LOCAL FUEL PLC

SHOREHAM OIL TERMINAL

OVERFILL PROTECTION

This report has been prepared as a Functional Safety Assessment Stage 5 “Modification”.

ACTION 1:

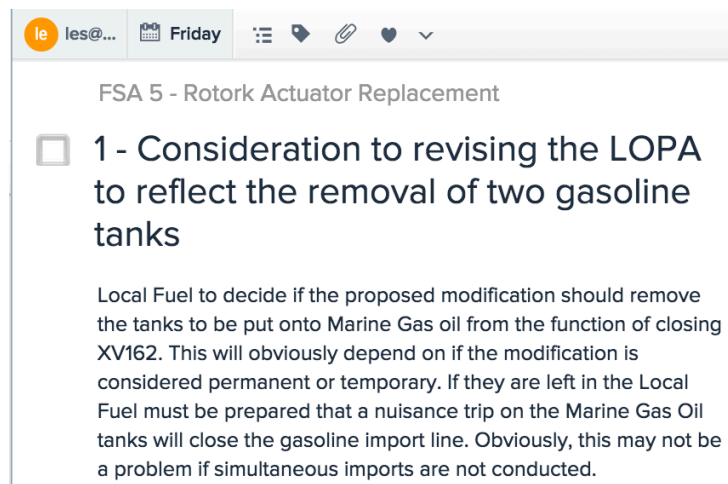
5.2.2 *Has the Safety Integrity Level (SIL) for each SIF been allocated. BS EN Clause 9.*

Section 4.6 of the SRS details the SIF requirements for Tanks 1, 2, 3 & 4, which prior to the proposed Marine Gas Oil modification were all available for gasoline. As stated previously the LOPA considered that only two of these tanks would be utilised.

Action 3:

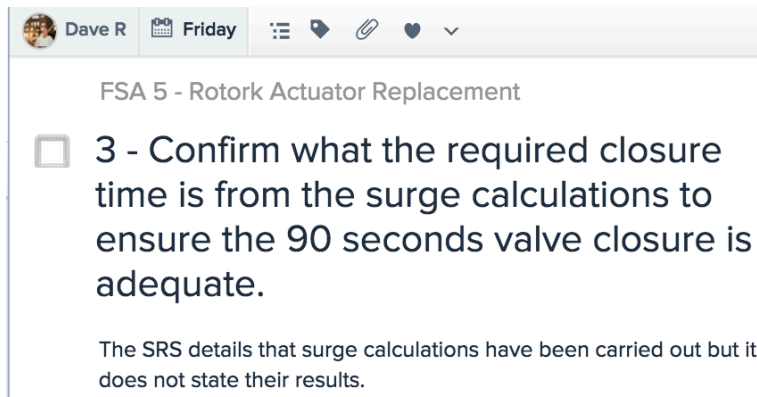
5.2.7 *Are performance requirements defined. (e.g speed of closure of valve). BS EN Clause 10.*

Section 4.6 of the SRS defines the requirements of slow closure of the final element to prevent pipeline surge. As the actuator is electrically operated there should be no difficulty in achieving the stated 90 seconds closure time. Section 2.3 defines that surge calculations have been carried out but it does not define what the actual safe closure time is.

Action 4:

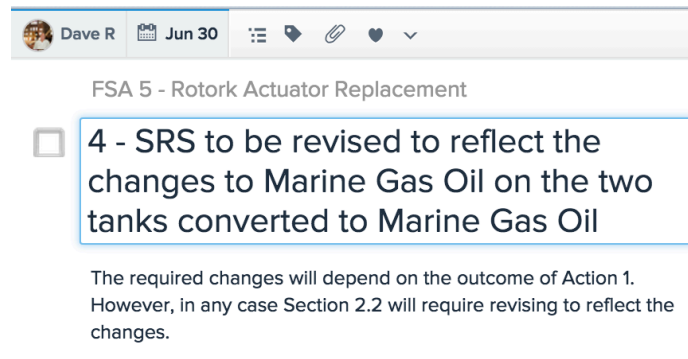
- Section 2.2 of the SRS details that activation of a high level in any of the four gasoline tanks Tank 1, 2, 3 & 4 will close the common import valve XV162. Activation of any of the remaining Tank high level sensors will provide an alarm. However, Section 4.6 of the SRS contradicts this is stating in the section “Safe State” that they also stop the flow to all tanks.
 - Action 1 previously requires Local Fuel plc to consider if the Tanks to be converted to Marine Gas Oil should operate on the gasoline import valve. The conclusion to this will also have an impact in modifying the SRS to reflect how the modified system is to operate.

Action 6:

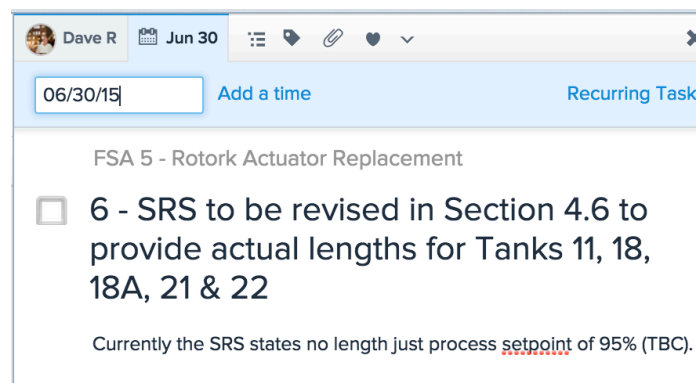
- Section 4.6 details the individual tank activation point for all tanks with the exception of tanks 11, 18, 18A, 21 & 22 were it states 95% (TBC).

Action 8:

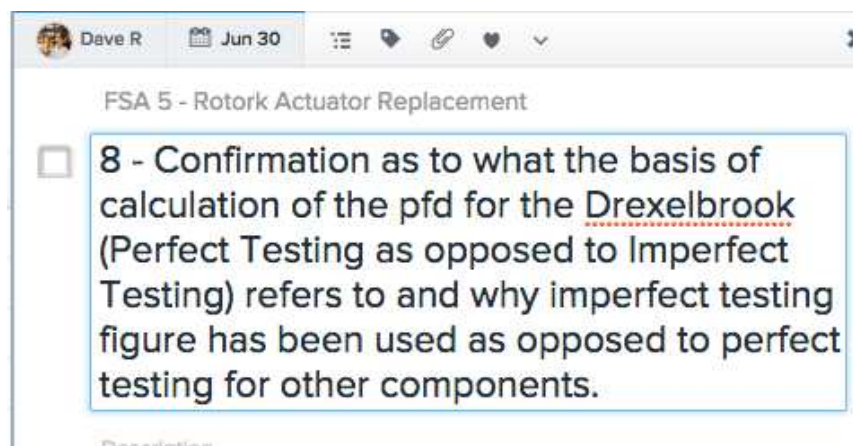
The calculation within the SIL Verification document Section 6.5 utilises the above data and confirms that a PFD = 3.38×10^{-4} it is noted that the calculation refers to this pfd being for perfect testing and imperfect testing provides a pfd of 8.57×10^{-4} . The device has a SFF of 0.93 and as such satisfies HFT = 0 in accordance with BS EN 61508.

REVISION B OF FSA – ACTION 8 CONFIRMS 8.57×10^{-4} .

Action 13:

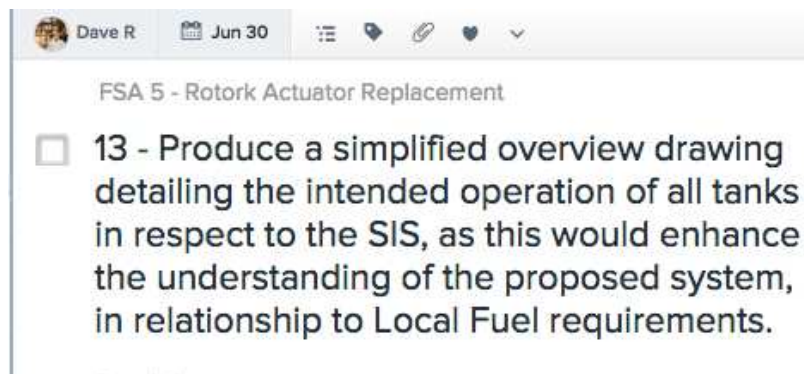
It is felt that it would be unpractical to remove this enhancement, in line with the current operating methods of Local Fuel, however, it is felt that a simplified overview drawing

detailing the intended operation of all tanks in respect to the SIS would enhance the understanding of the proposed system, in relationship to Local Fuel requirements.
